Change Notice Number TPA-CN- 0894	TPA CHANGE NOTICE FORM	Date: June 24, 2020
--------------------------------------	------------------------	------------------------

Document Number, Title, and Revision: DOE/RL-2013-48, <i>Operation and Maintenance Plan for the 100-KR-4 Pump and Treat Systems</i> , Rev. 1	Date Document Last Issued: July 18, 2018
---	---

Description of Change:
This change notice amends DOE/RL-2013-48 to update wells associated with the 100-KR-4 P&T systems through the end of 2019 and reduces the in-process sampling frequency for the IX resin vessels.

Figure 1-2. 100-KR-4 Operable Unit Pump and Treat System, 2017-2019

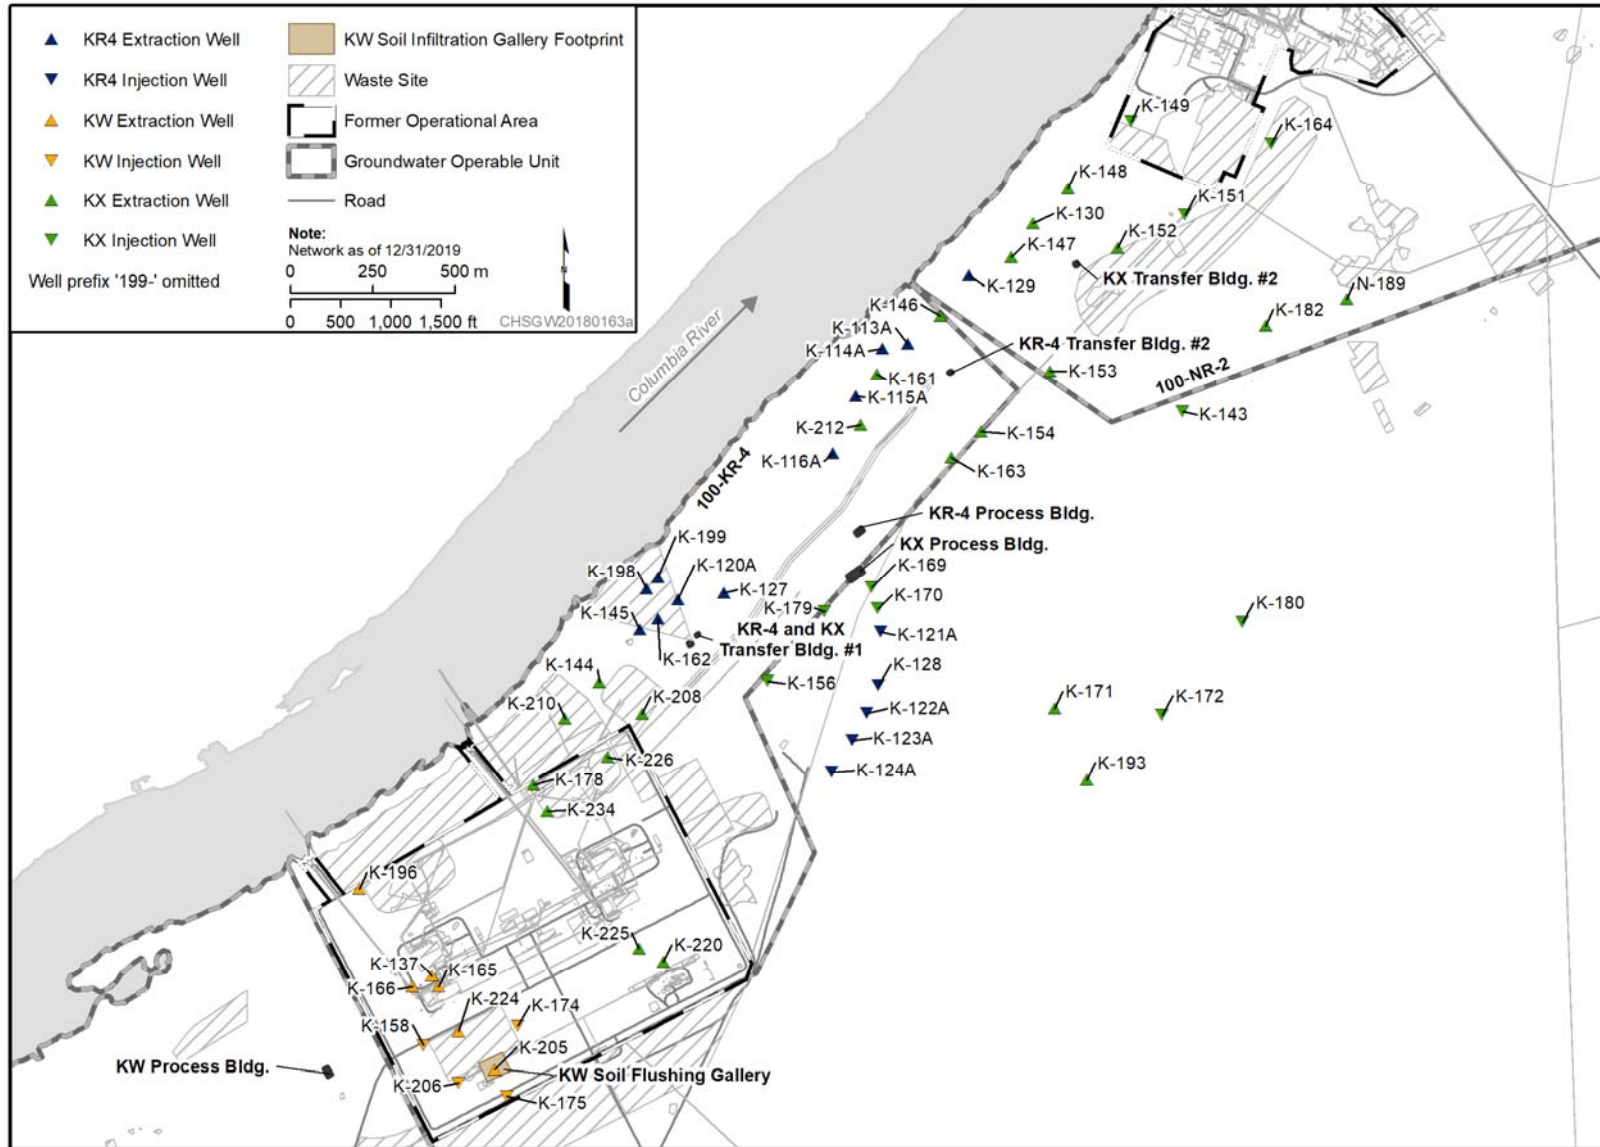
- The following changes are made:
- Page 1-3 - Changed 2017 to 2019 and updated the list of annual P&T reports.
 - Page 1-4 – Changed 2017 to 2019.
 - Page 1-5 – Update Figure 1-2 to current conditions as of the end of 2019.
 - Page 1-7 – Update Figure 1-4 to incorporate use of an infiltration gallery.
 - Page 1-8 – Changed 2017 to 2019; Update Table 1-1 and Table 1-2 to reflect current conditions through the end of the 2019.
 - Page 4-2 – Update Table 4-2 to reduce sampling frequency for IX vessels.
 - Page 8-3 – Updated and added references listed on Page 1-3.
